DESIGN REVIEW COMMITTEE MEETING AGENDA
Thursday, January 10, 2019, 4:00 PM
City Hall, 616 NE 4th Avenue

11TH AVENUE DUPLEX

FILES: CUP18-01 AND DR18-09

PROPOSAL: To request conditional use approval to construct a duplex residential structure on a single family lot

C3

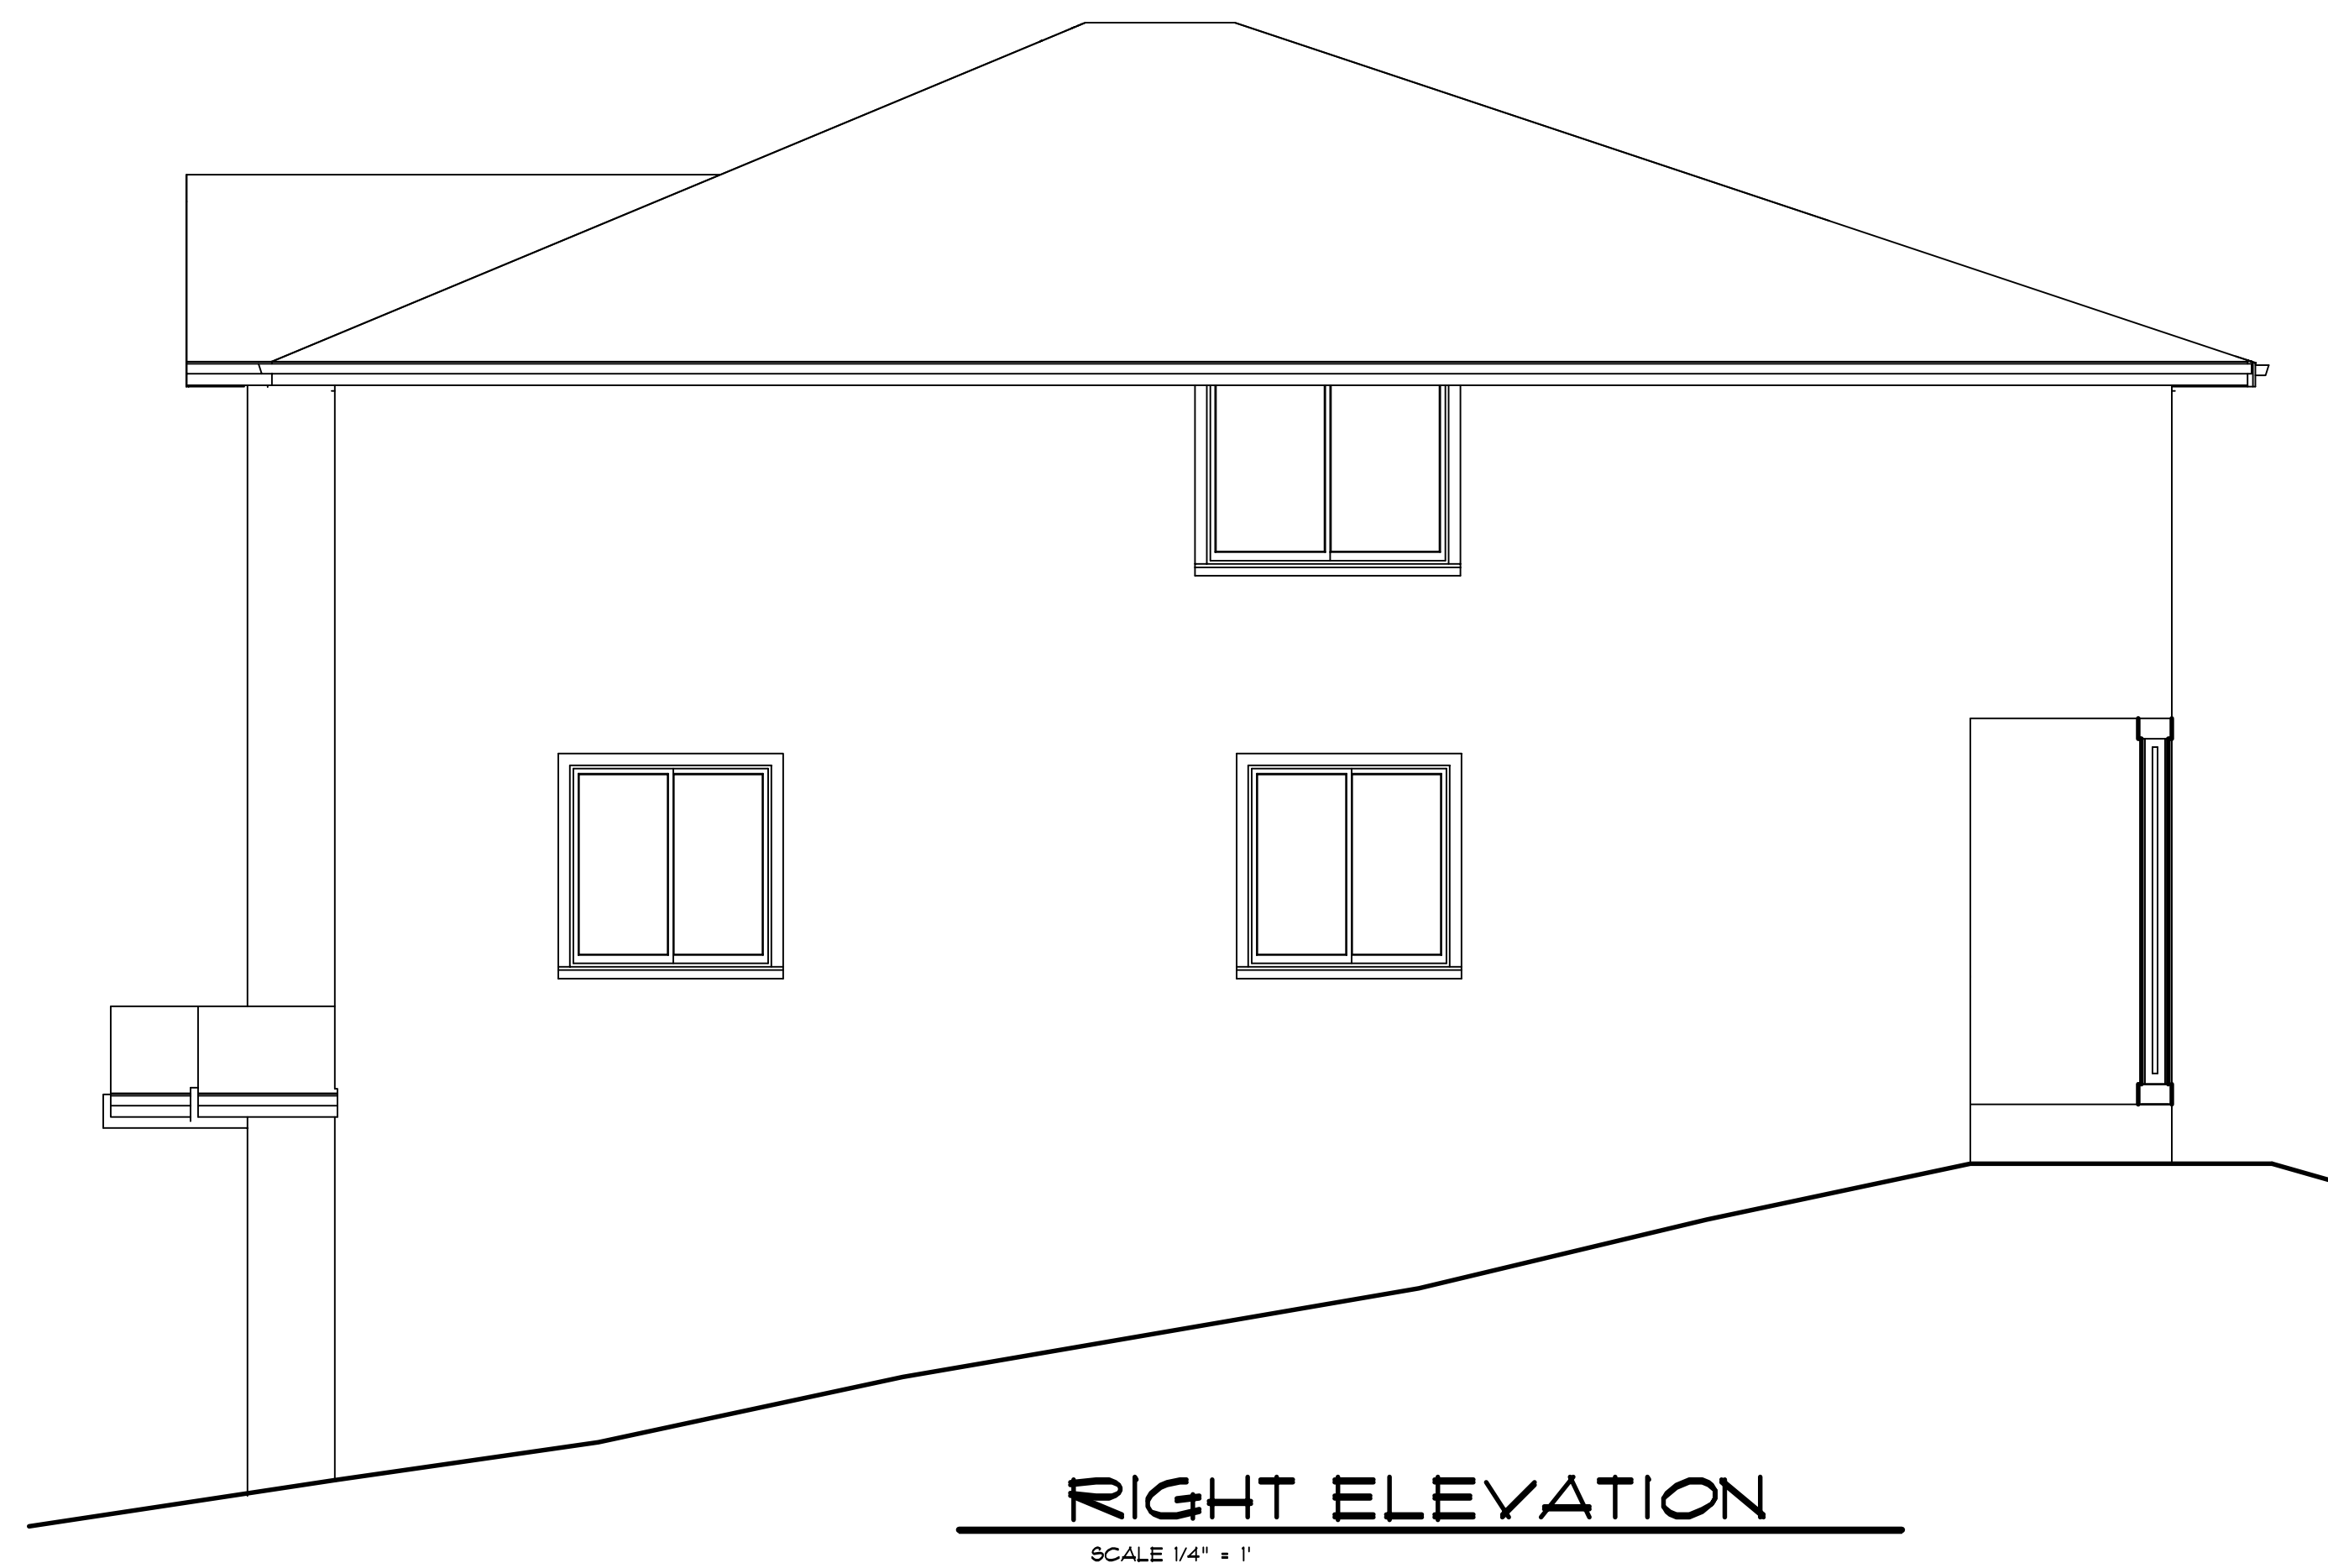
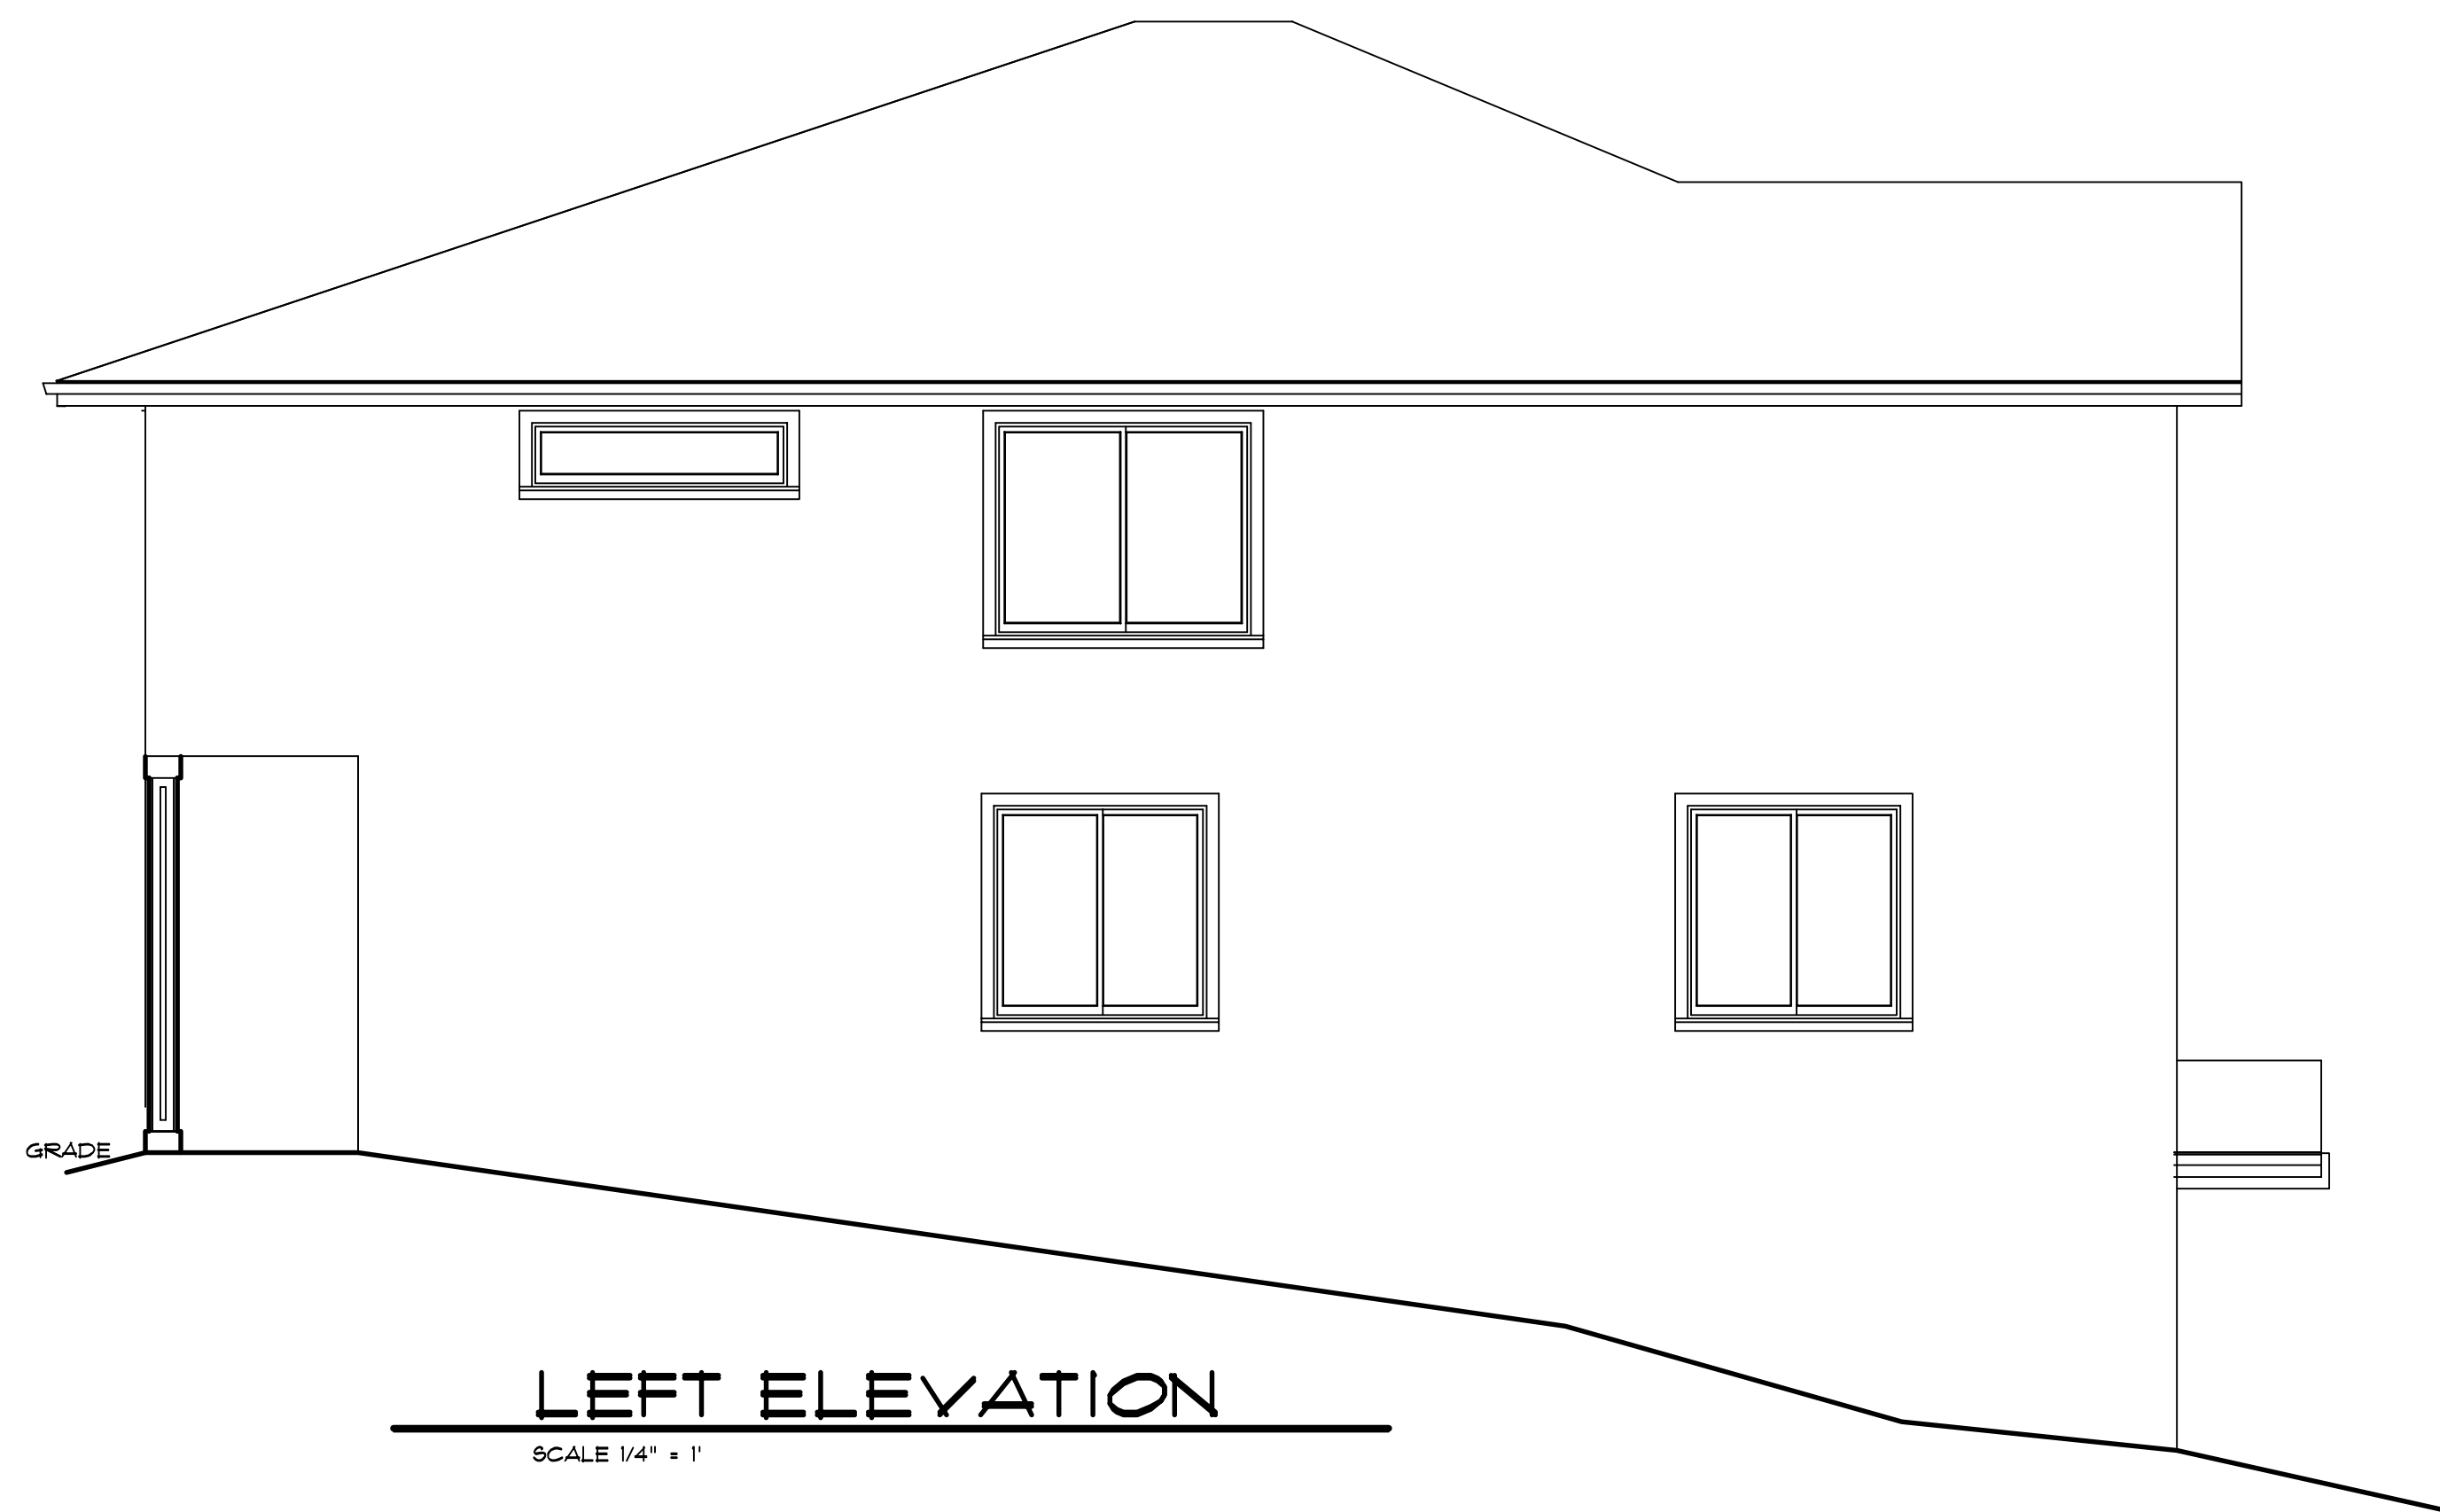
LANDSCAPING: Per drawing C3, the applicant is proposing a tree in the front yard of each dwelling unit. A street tree for every new residential unit is a requirement per CMC17.19.030 (F)(1), *"Each dwelling unit within a new development shall be landscaped with at least one tree in the planting strip of the right-of-way, or similar location in the front yard of each dwelling unit, with the exception of flag lots and lots accessed by tracts. Required trees shall be a minimum two-inch diameter at breast height (dbh) to create a uniform streetscape (dbh is four and one-half feet above the ground as measured from upside of tree)." The proposed tree in front of each unit complies with this standard.*

Findings: The landscape plan includes ground cover along the side and rear yard of Oregon grape and Kinnickinick. Front yard planting appears to include grass.

Findings: The application did not provide a proposal for an irrigation system. A condition to this effect shall be included to address this criterion.

Findings: The application includes five feet of landscaping as required between the single family residential properties to the west and east of the lot. The front yard landscaping does not group the trees and shrubs. A condition to remedy this is included.

Findings: Sheet C3 illustrates landscaping along the entire perimeter of the site to include evergreen trees at the rear of the site and ground cover plants covering the majority of the yard areas.

12. A revised landscaping plan must be provided no later than building plan submittal, and approved by the Planning Division prior to commencement of site construction. *The landscape plan will include an irrigation plan, and will group the front yard plantings as required per CMC§18.13.055.*
